RFB NO. 311005 - ADDENDUM NO. 2

REROOF DANE COUNTY STOUGHTON HIGHWAY GARAGE

DRAWINGS: Revised Sheet 1 of 2

ROOF PLAN
SCALE: 1/8" = 1'-0"

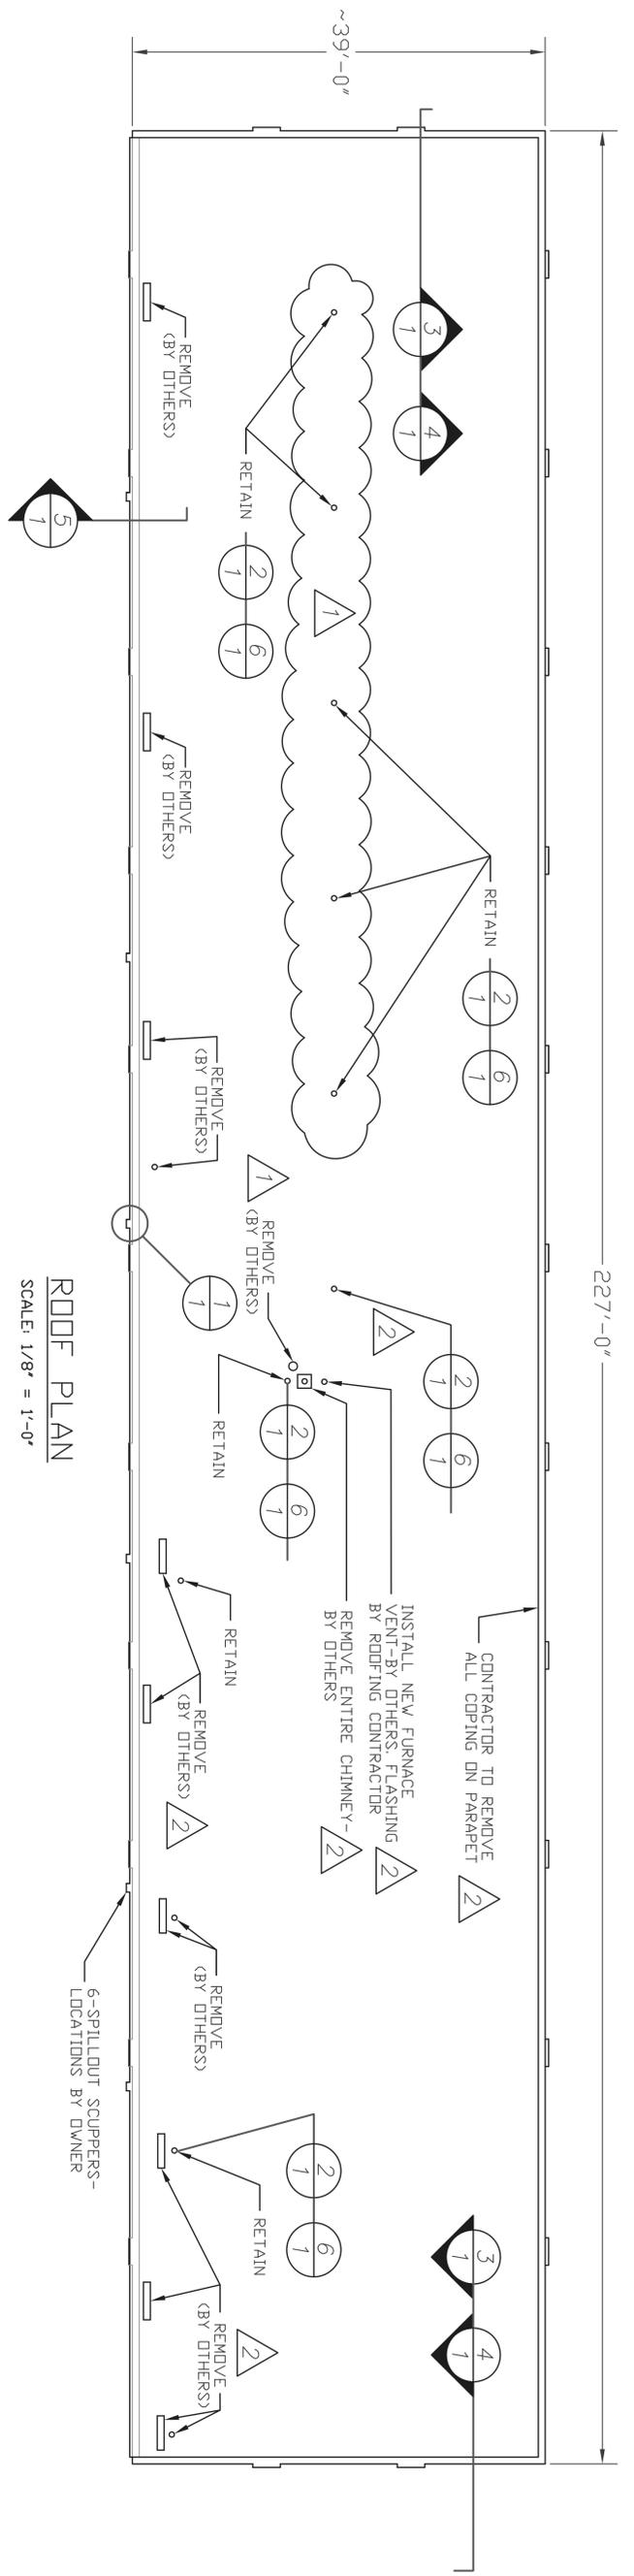
INSTALL NEW FURNACE VENT-BY OTHERS. FLASHING BY ROOFING CONTRACTOR
REMOVE ENTIRE CHIMNEY-BY OTHERS

CONTRACTOR TO REMOVE ALL COPING ON PARAPET

6-SPILLOUT SCUPPERS-LOCATIONS BY OWNER
